**Board of Adjustment**  
**Meeting Agenda**  
**City of Creve Coeur Government Center**  
**300 North New Ballas Rd**

**2. Variance Requests for the Property at 11334 St. Paul Street to Allow for a Sunroom Addition to the Home to Project Up to 10 Feet 9 Inches into the Rear-Yard Where the Required Rear Yard Setback is 30 Feet**

**APPLICATION TO THE BOARD OF ADJUSTMENT FOR  
VARIANCE REQUESTS FOR THE PROPERTY AT 11334 ST. PAUL STREET  
TO ALLOW FOR A SUNROOM ADDITION TO THE HOME TO PROJECT  
UP TO 10 FEET 9 INCHES INTO THE REAR-YARD WHERE THE  
REQUIRED REAR YARD SETBACK IS 30 FEET**

**REPORT PREPARED BY:** Whitney Kelly, AICP, City Planner  
**DATE:** 7-6-2017  
**ATTACHMENTS:** Applicant's Materials submitted on May 11, 2017  
Public Comments Received by July 10, 2017

Figure 1: Close-up of the site plan with the proposed sunroom.

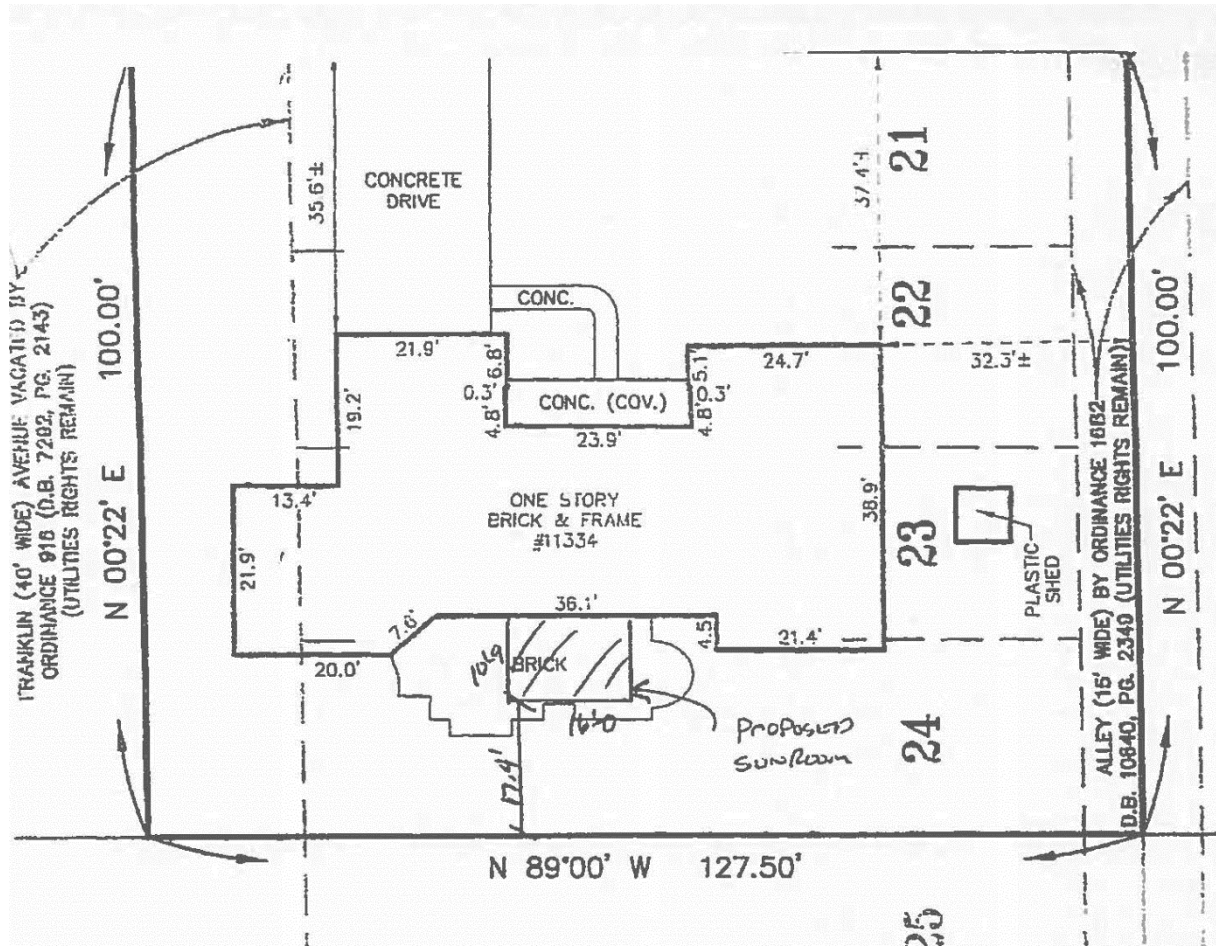
designation (C-RDD) has a minimum rear yard of 30 feet. The home is non-conforming, and the addition would further decrease the rear yard to 17.4 feet.

While it is unclear how the existing home was developed within the setback, it is the Applicants' decision to place the sunroom addition further within the setback that creates the need for the variance. The applicants have provided no evidence of a unique hardship.

No evidence has been submitted that suggests that the property is so adversely affected by the zoning district regulations that they will cause an extreme hardship. It is the Applicant's decision to seek approval of the sunroom addition at approximately 17.4 feet from the rear property line, instead of maintaining the existing rear yard setback.
